My Objection to planning application HGY/2023/1199.

Re Planning Application HGY/2023/1199
At
Applicants Property: 31a Riverside Road London N15
Dated 2nd May 2023.

Our property: 31 Riverside Road London N15

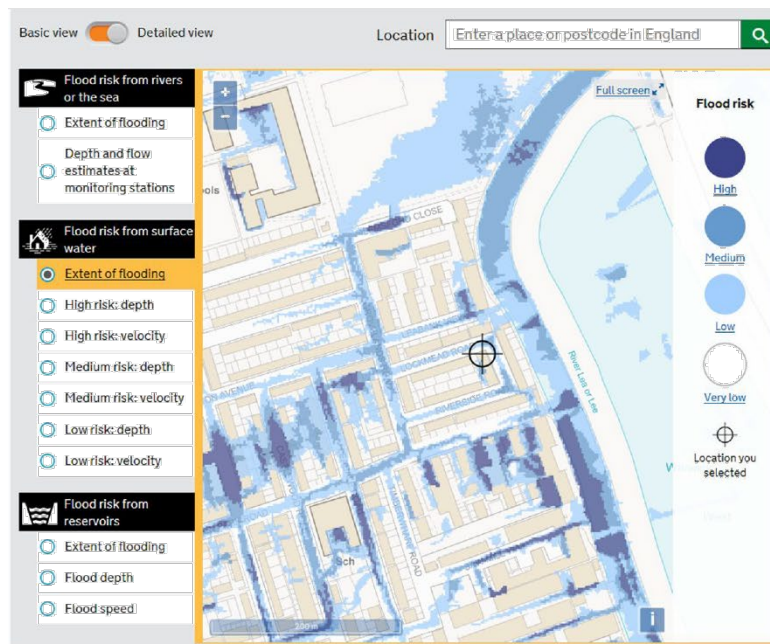
Para 3 **We Quote** – *“A trial hole will be excavated on site adjacent to the existing property to establish the depth of the existing foundations.”* **Our Response** –

- a) Why were trial hole and soil sample tests not carried out before the supposed revised report? Because we must assume that a party wall agreement has not been drawn up between any of the concerned parties, for deep soil analysis tests. No such works can be carried out within 4m of any neighbouring property without such an agreement in place.
- b) The existing foundation of what property? The existing building has shallow foundations.

c) We have established that there is no existing basement.

Flooding from Surface Water

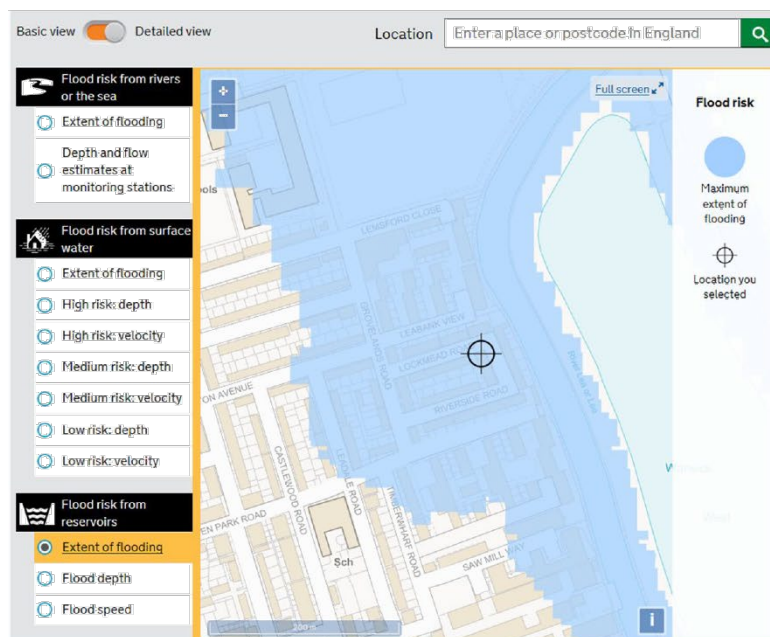
We Quote – The site is not in an area at risk of flooding from surface water although Lockmead Road and Riverside Road have some Low-risk points.

The site is in an area at risk of flooding from reservoir.

14. **We Quote** – “*Flooding from Reservoirs*”. **Our Response** – With reference to the Environment Agency (EA) Flood Map for Planning, the proposed development is located within Flood Zone 1. However, the site is located within the EA modelled maximum flood extent following reservoir failure and therefore requires an FRA under the NPPF. Furthermore, the Haringey Strategic **Flood Risk Assessment (SFRA, 2013)** states that:
